Planning Commission Staff Report

SUBJECT: DR22-28, LINDSAY AND BASELINE COMMERCIAL

Approve the Findings of Fact and approve DR22-28, Lindsay and Baseline: site plan, landscape, grading and drainage, elevations, floor plans, lighting, colors and materials for approximately 2.03 acres, generally located at the SEC corner of Lindsay and Baseline Roads and zoned General Commercial (GC).

DR100

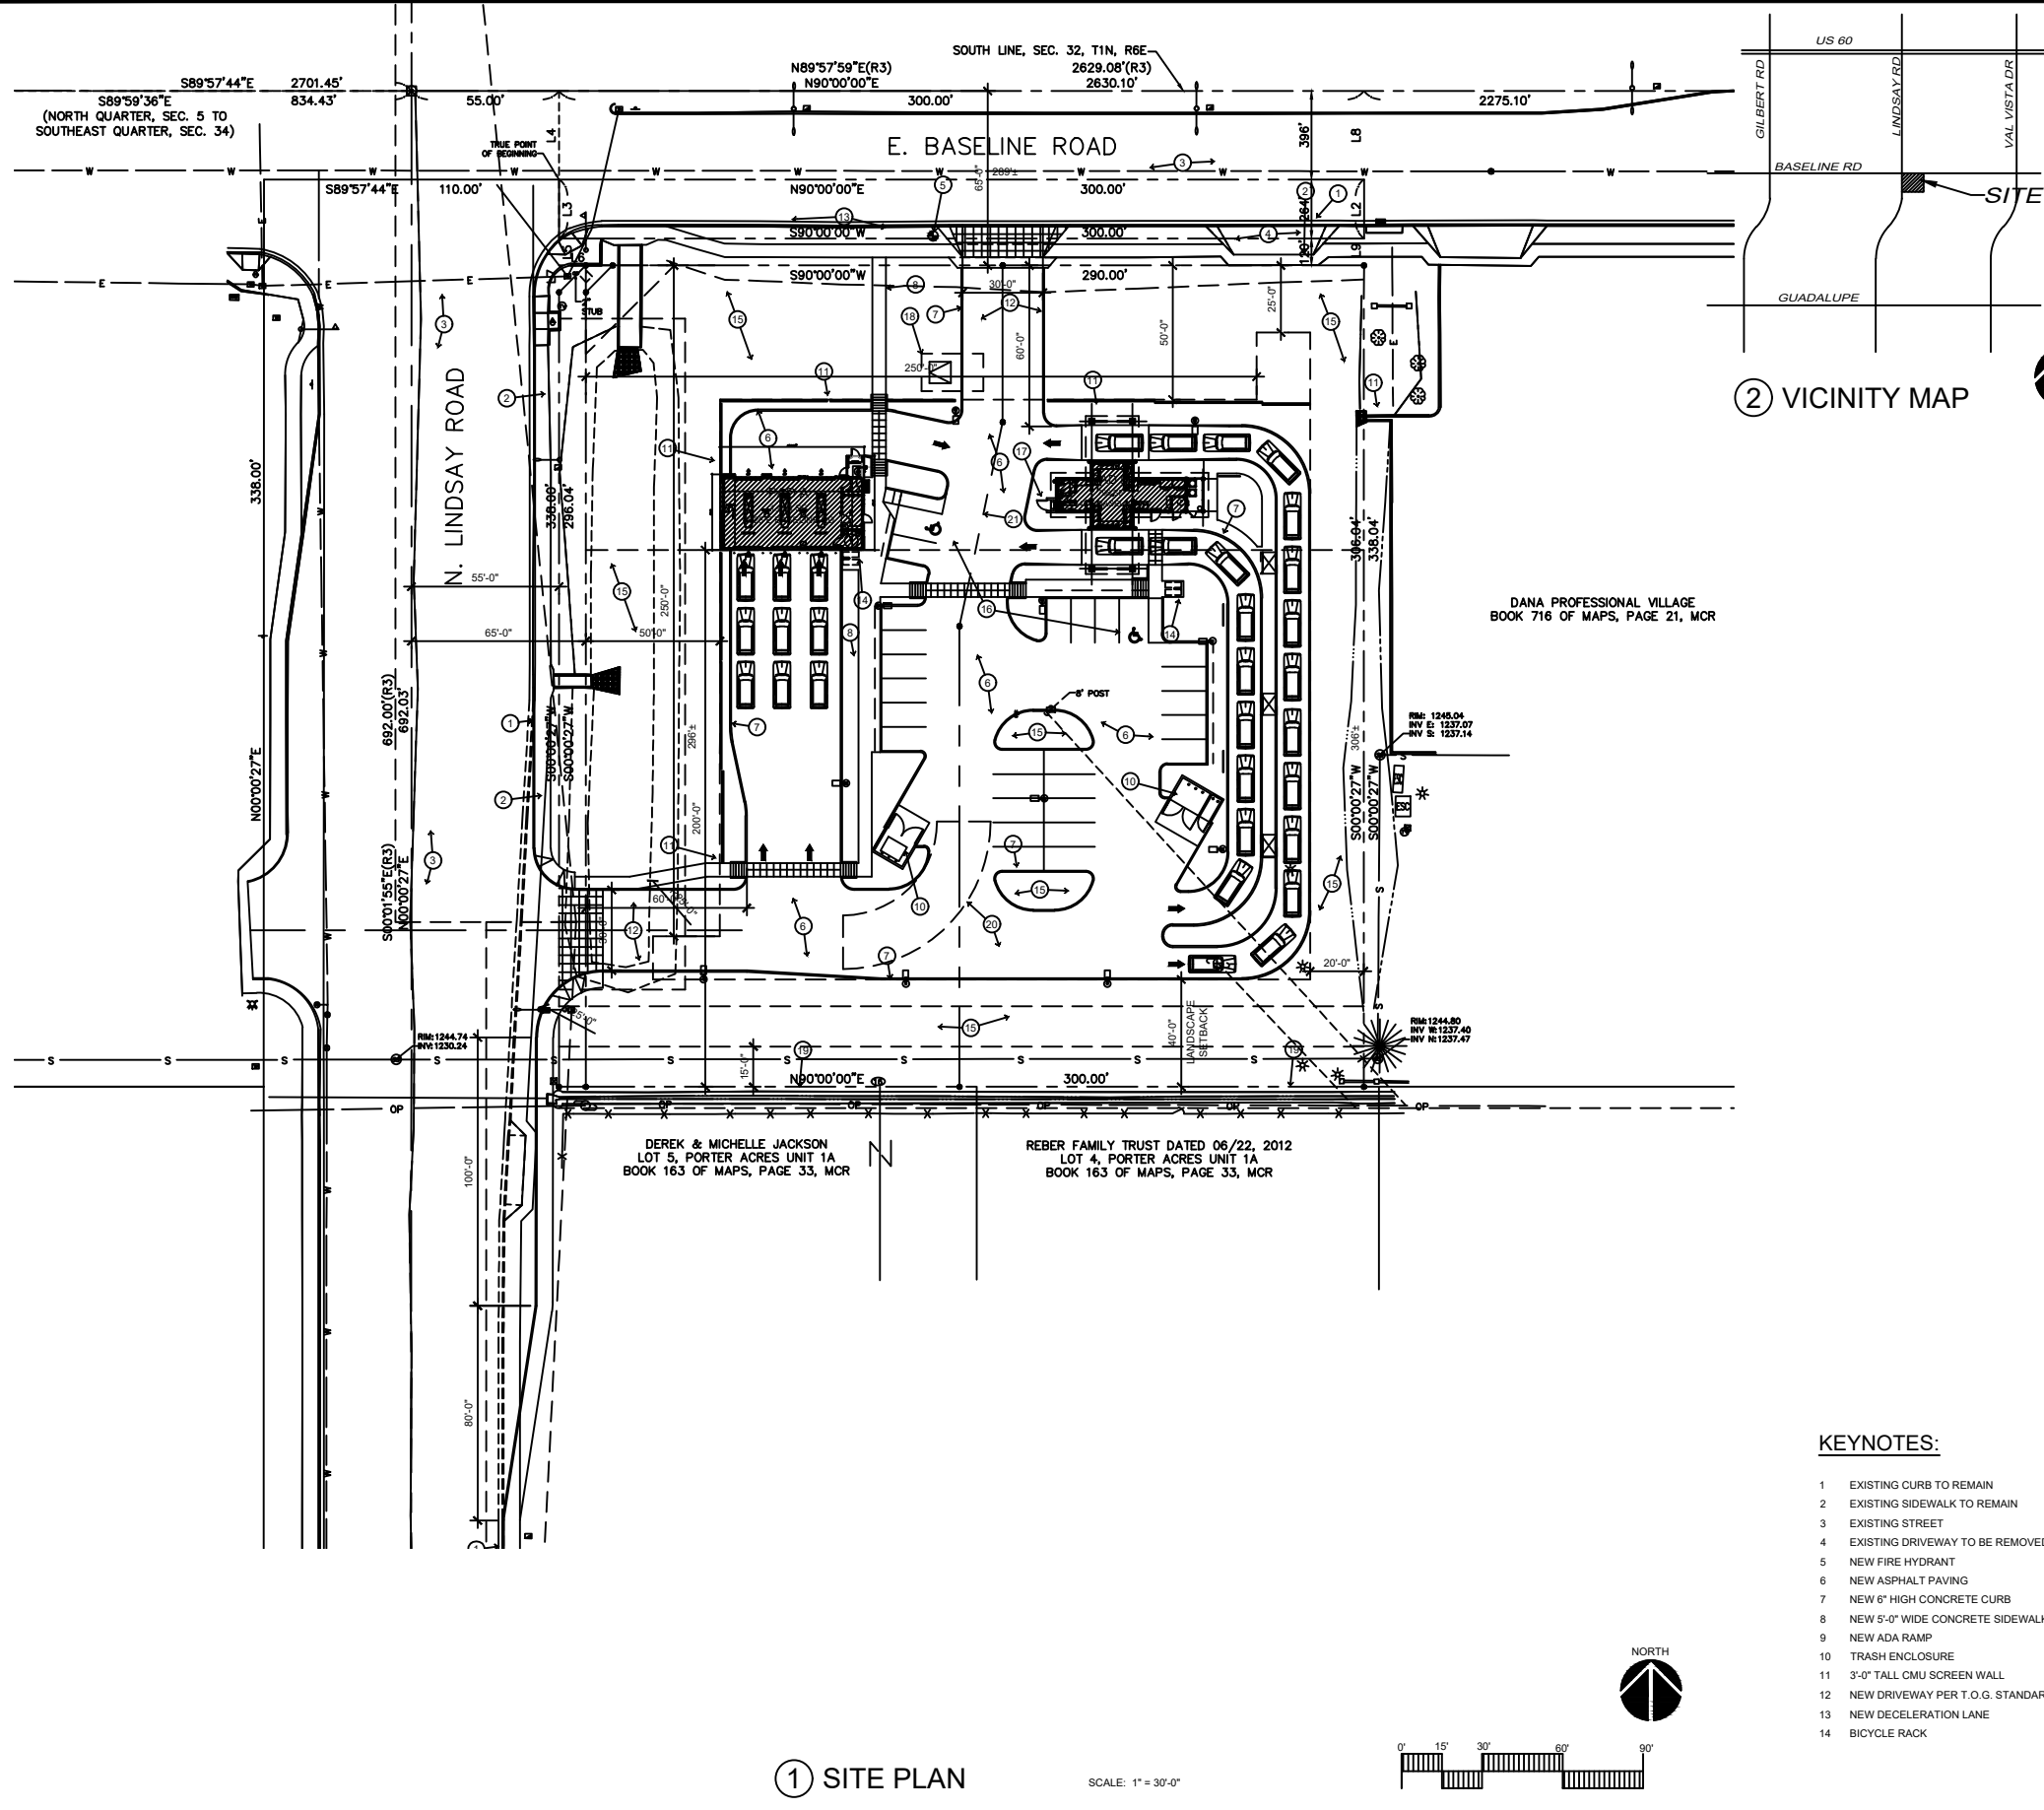
Access is provided to the site with a pair of RI/RO driveways, with one located on Lindsay Road and one on Baseline Road. The driveway on Lindsay is only approved contingent on the removal of the retention easement which currently prohibits development of the driveway. The driveway on Baseline was permitted in the selected location because of approval from planning staff of the City of Mesa, which allowed the driveway location so long as City requirements were met for visibility triangles and the ultimate design of the deceleration lane adjacent to the RI/RO driveway.

Traffic, Clint Emery & Site Plan Page DR100

SHEET NO.
DR 120
ISSUE DATE: 21 FEB 2022

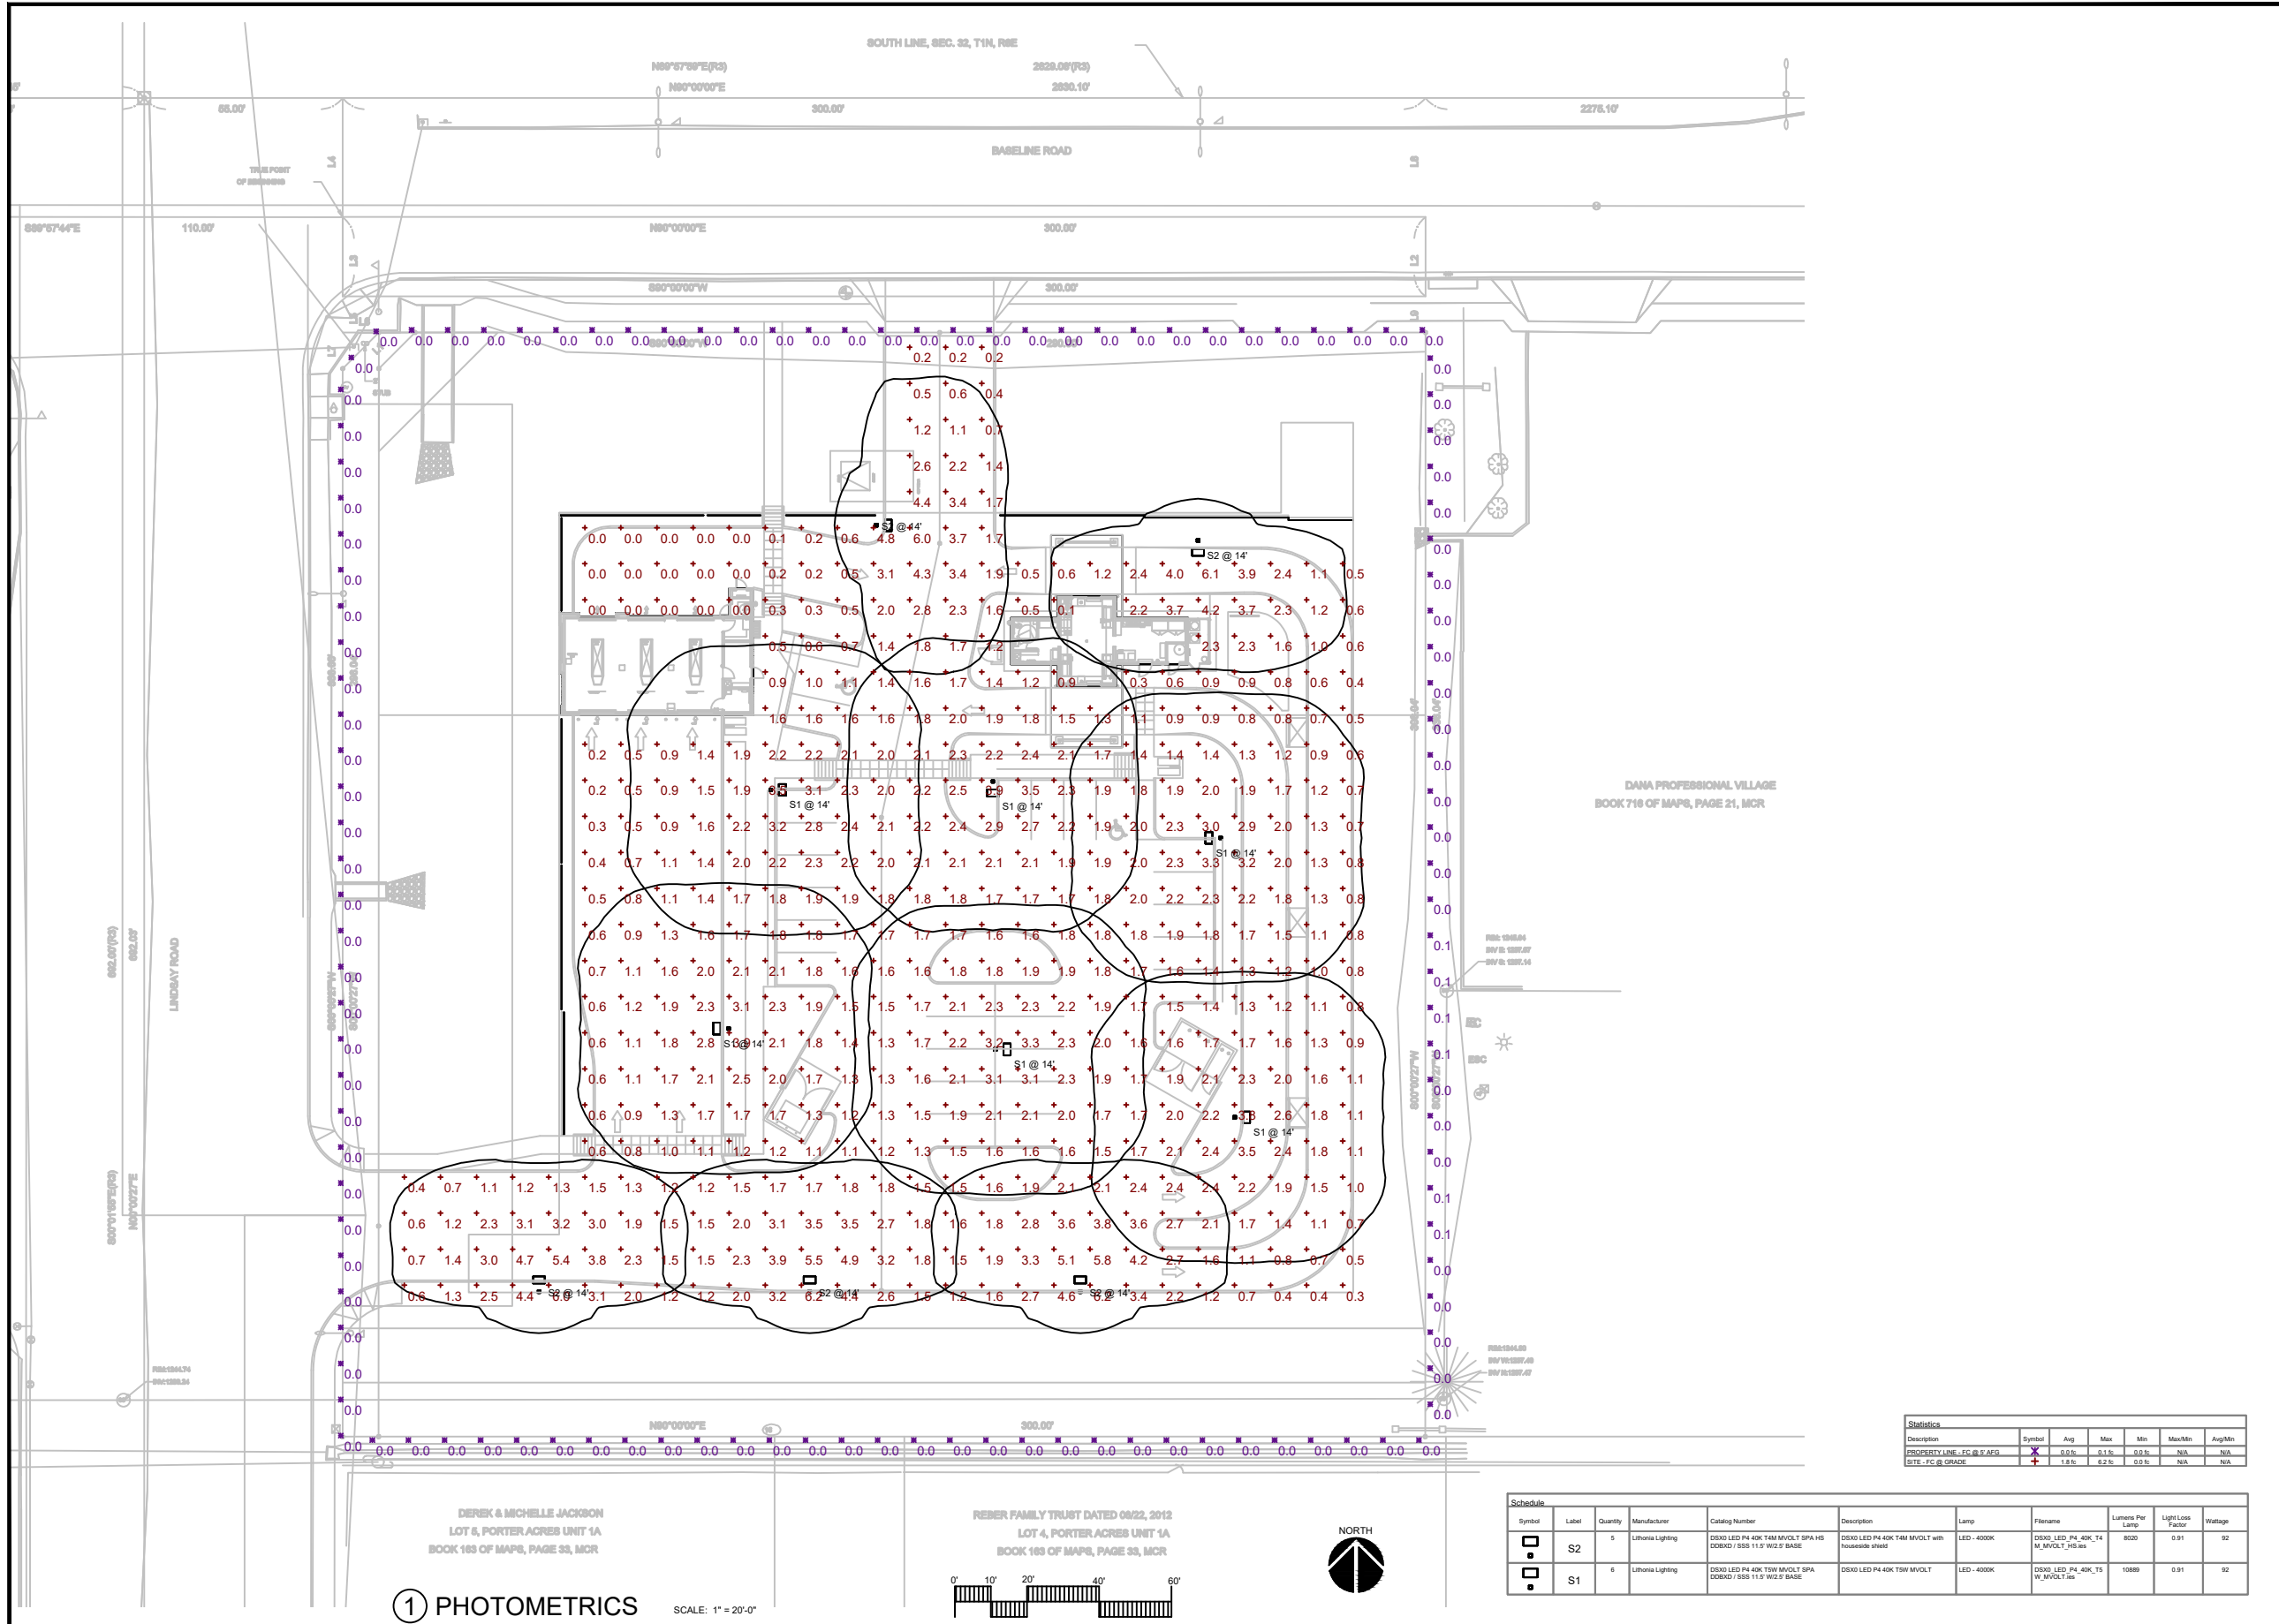
As a condition of approval, Town staff has expressed that canopy lighting shall be provided for the Gravity Coffee building to improve building security and function of building in mornings and evenings without sunlight. Updates shall be provided to the photometric plan to accurately depict the addition.

As a condition for approval, Town staff has requested updates to the photometric plan to accurately depict the sconce lights included on the Take 5 structure and accompanying updates to lighting cut sheets to provide information about the sconce lights included on the building.

- f. Canopy lighting shall be provided for the Gravity Coffee structure in accordance with Code, with photometric plan updated to identify effects of lighting on surroundings from canopy lighting prior to submittal for construction documents and the issuance of building permits.
- g. Applicant shall submit to planning an updated photometric plan to include lighting effects created by sconce lighting on Take 5 structure prior to submittal for construction documents and the issuance of building permits.
- h. The approval of a Comprehensive Sign Package encompassing both sites is required prior to submitting for sign permits. Administrative Design Review required for monument signage if specific locations are not identified within the CSP.
